ADDENDUM TO THE CONTRACT

F STREET RECONSTRUCTION Contract No. BE17-215

ADDENDUM NO.: THREE

DATE ADDENDUM ISSUED: August 1, 2017

*F STREET RECONSTRUCTION
CONTRACT NO. BE17-215
ADDENDUM NO. THREE*

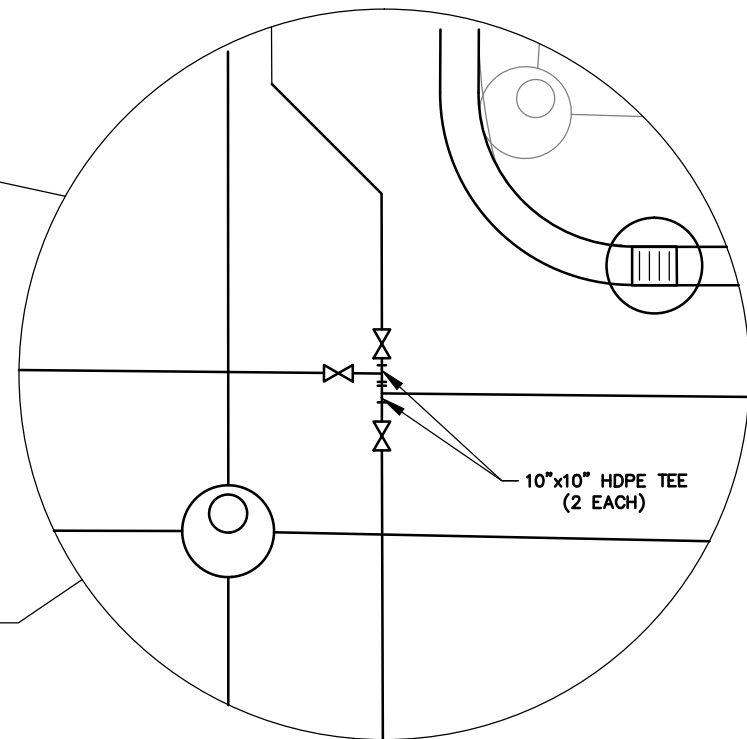
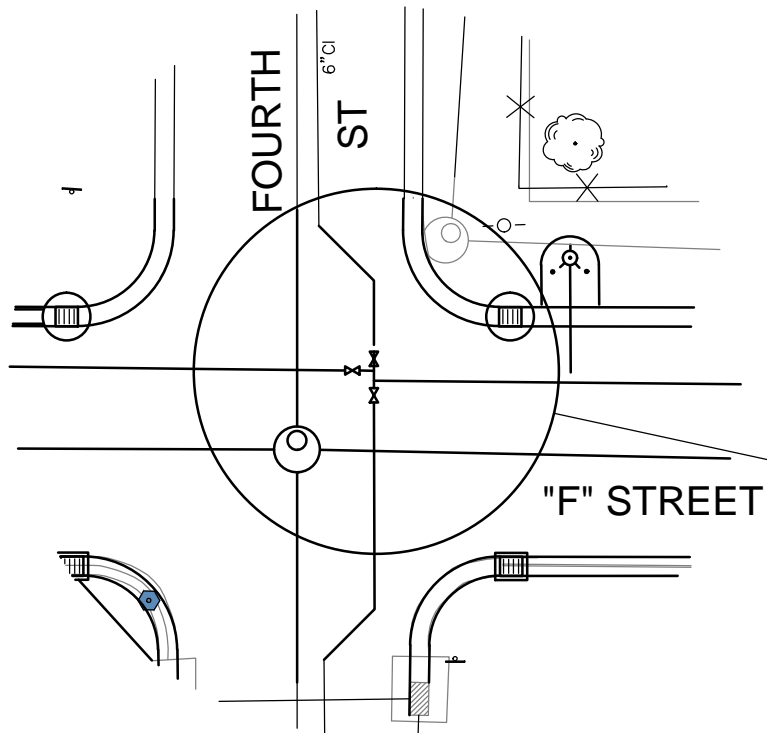
Item No. 18: **Add** attached intersection detail of Fourth Street and F Street, labeled Addendum No. Three.

REMOVE THE 10"x10" HDPE CROSS AT THE INTERSECTION OF F ST. AND 4TH ST. INSTALL 2 EACH - 10"x10"x 10" TEES WITH THE INLINE FLOW ALONG 4TH STREET AND OFFSET FLOW RUNNING UP AND DOWN F STREET. USE MANUFACTURERS ALLOWABLE DEFLECTION TO RESTORE ORIGINAL PLANNED PIPE ALIGNMENT.
